Project	IEEE 802.16 Broadband Wireless Access Working Group < http://ieee802.org/16 >
Title	Supporting an ACK signal per layer in HARQ MIMO
Date Submitted	2005-01-21
Source(s)	Jinyoung Chun, Bin-Chul Ihm, Yongseok Jin, Voice: 82-31-450-7187 Changjae Lee Fax: 82-31-450-7912 LG Electronics,Inc. [mailto: { jychun03, jayjay, bcihm, cjlee16 } @lge.com] 533,Hogye-1dong,Dongan-gu, Anyang-shi,Kyongki-do,Korea
Re:	This is a response to a Call for Comments on IEEE P802.16e-D5a
Abstract	We suggest supporting an ACK signal in HARQ MIMO.
Purpose	This document is submitted for review by 802.16e Working Group members. <u>Pink line indicates the revised text.</u>
Notice	This document has been prepared to assist IEEE 802.16. It is offered as a basis for discussion and is not binding on the contributing individual(s) or organization(s). The material in this document is subject to change in form and content after further study. The contributor(s) reserve(s) the right to add, amend or withdraw material contained herein.

Supporting an ACK signal per layer in HARQ MIMO

Jinyoung Chun, Bin-chul Ihm, Yongseok Jin, and Changjae Lee
LG Electronics

Figure 1. The example of DL ACK bits allocation of the BITMAP for MIMO

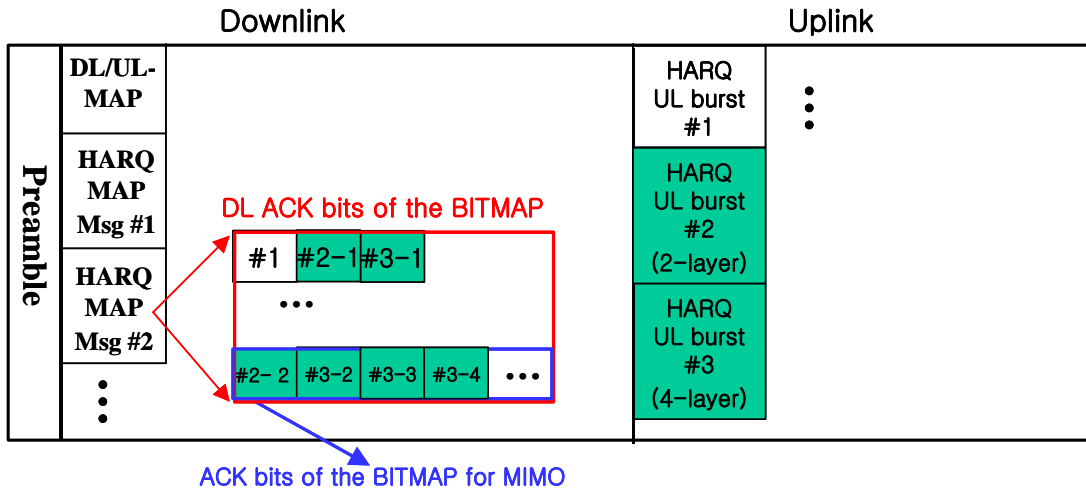
In order to transmit UL ACK signals per layer with guarantee of maintaining backward compatibility with REVd SS, UL ACK signals for DL MIMO enabled bursts shall be allocated after ACK signals of all bursts are allocated. When bursts are MIMO enabled, however, ACK signals of the first layer of bursts are allocated instead of ACK signals of overall bursts. And after ACK signals of all bursts are allocated, ACK signals of other layers of bursts are allocated as shown in the figure 1.

~~However w~~When a MIMO enabled MSS transmits a H-ARQ enabled burst, the SS shall receive H-ARQ ACK bits of the BITMAP as many as the number of layers, and ~~and the ACK bits of the BITMAP shall be allocated~~ is used to the first layer of a H-ARQ enabled burst. And after ACK bits of all bursts are allocated in BITMAP, ACK bits of other layers are allocated by the order of layers in the same burst in MIMO Compact DL-MAP IE and then bursts in Compact DL-MAP IE.

Figure 2. The example of UL ACK Region allocation for MIMO

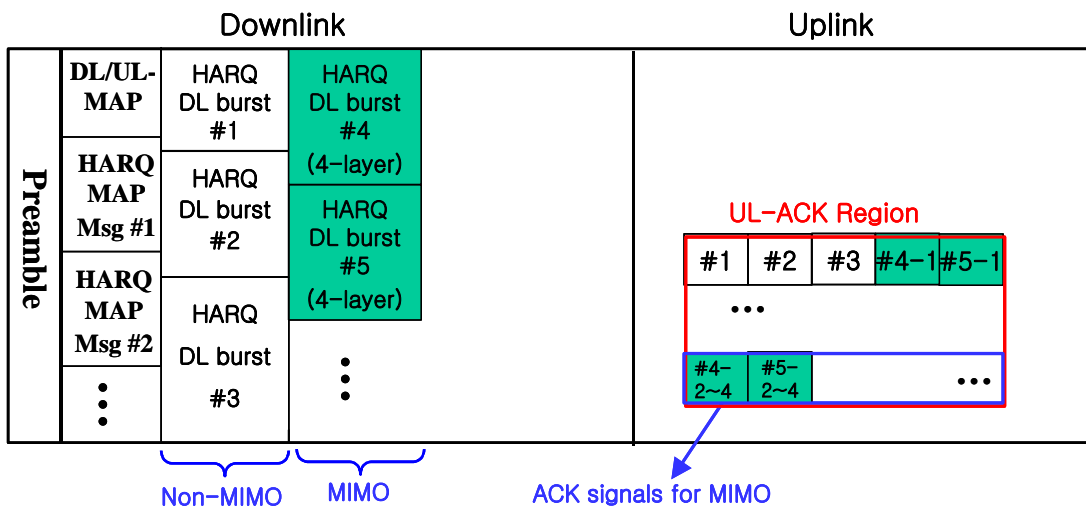
The allocation of uplink ACK signals is similar to the allocation of downlink ACK signals. But if MSS has ACK half-subchannels as many as the number of other layers except the first layer, the overhead of BW is larger as (the number of other layers)*(a half-subchannel).

Therefore we suggest that ACK signals of other layers be transmitted using codeword of a half-subchannel as shown in the figure 2. The method increases the efficiency since BS can get the ACK signal per layer by using just a half-subchannel per MIMO enabled burst.

~~However w~~When a MIMO enabled SS transmits a H-ARQ enabled burst, the SS shall transmit H-ARQ ACK signals at half subchannels in H-ARQ Region as many as the number of layers, and the an ACK half-subchannels in H-ARQ Region shall be allocated is used to the first layer of a H-ARQ enabled burst. And after ACK half-subchannels of all bursts are allocated in H-ARQ Region, ACK signals of other layers are allocated in H-ARQ Region by the order of bursts in layers in MIMO Compact UL-MAP IE. ACK signals of other layers except the first layer are represented to modulated signals of a half-subchannel in Table xxx. When the number of layer in a MIMO enabled burst is less than 4, BS doesn't care the signal of other layers.
